Preliminary examination of project documentation

For the project: "New construction of a dual-purpose facility (with protective properties of a radiation shelter) with a capacity of 100 people for the Kobizhchansky ZDO "Lesnaya Skazka" Bobrovitsky City Council at the address: 158 Kashtalyanivka St., Kobizhcha village, Nizhyn district Chernihiv region"

Location: 158 Kashtalianivka St., Kobyzhcha village, Nizhyn district, Chernihiv region

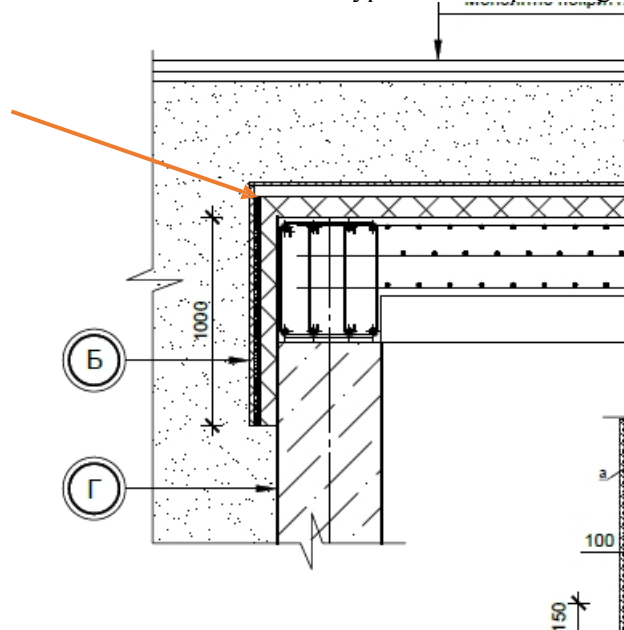
11. In section AR, sheet 5, section 1-1, the monolithic foundation slab design incorrectly shows an IZOLIT fishbone drainage membrane. However, this solution will not work, as a drainage layer of 10-30 mm crushed stone has already been installed under the foundation slab. In addition, I suggest using 20-40 mm crushed stone as a drainage layer, as it is a more drainage material.

12. The sections of AR sheets 5-6 do not show the joints between the floor structures and walls, the joints between the support slab and walls, or the joints between the parapet covers. The insulation structure of the external walls and basement, and the junction of the blind area to the wall are not shown. At the same time, individual junctions are shown on sheet 11 (A, B, C, D, E), but they are absent on the sections and it is not possible to determine where they are located.

13. In section AR, sheet 6, a different waterproofing design is shown on the outer surface of the walls than that shown in section KB on the outer walls of the ventilation shafts, sheets 35-36.

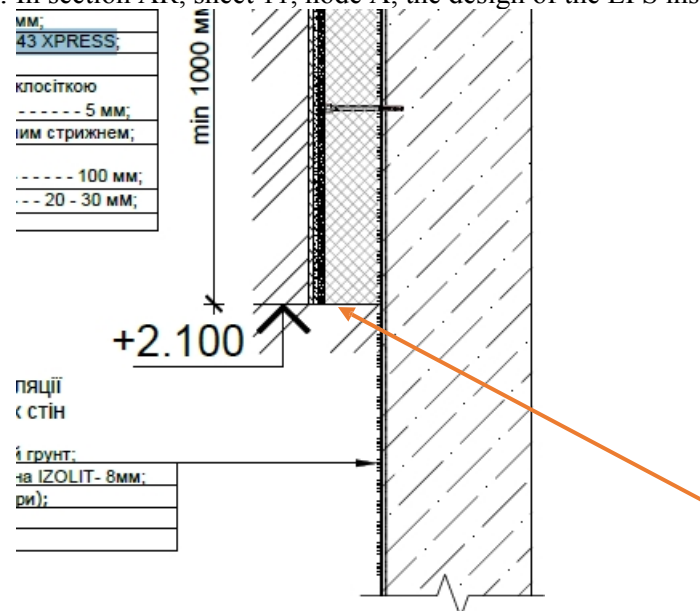
15. In section AR, sheet 11, node B does not show the connection of different types of insulation for floors and walls in non-corner areas. For example, how to connect two different types of waterproofing: Ceresit CP43 XPRESS and Ceresit CR 66.

16. In section AR, sheet 11, node B shows two types of adhesive for protecting EPS ST-83 and ST-85 insulation, with ST-85 being a universal material that can both bond and protect the insulation.

17. Section AR, sheet 11, node B shows two layers of waterproofing: Ceresit CR 66 and Ceresit CP 43 XPRESS mastic. These are applied one after the other. Ceresit CR 66 two-component polymer waterproofing is completely sufficient to ensure a high level of waterproofing. The use and cost of the structure are unclear.

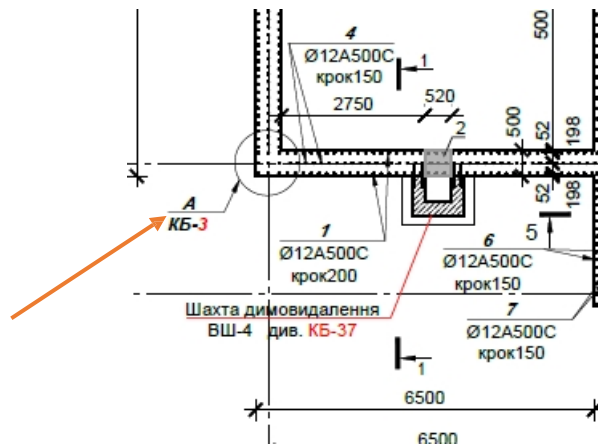
18. In section AR, sheet 11, node A, the design of the EPS insulation protection from the bottom to the end face is incorrectly shown.

19. In section AR, sheet 11, node A, the ST-15 primer is mistakenly shown instead of ST-16 under the decorative plaster finish.

In addition, to avoid additional work on priming the base for painting, you can order decorative plaster with paint already added.
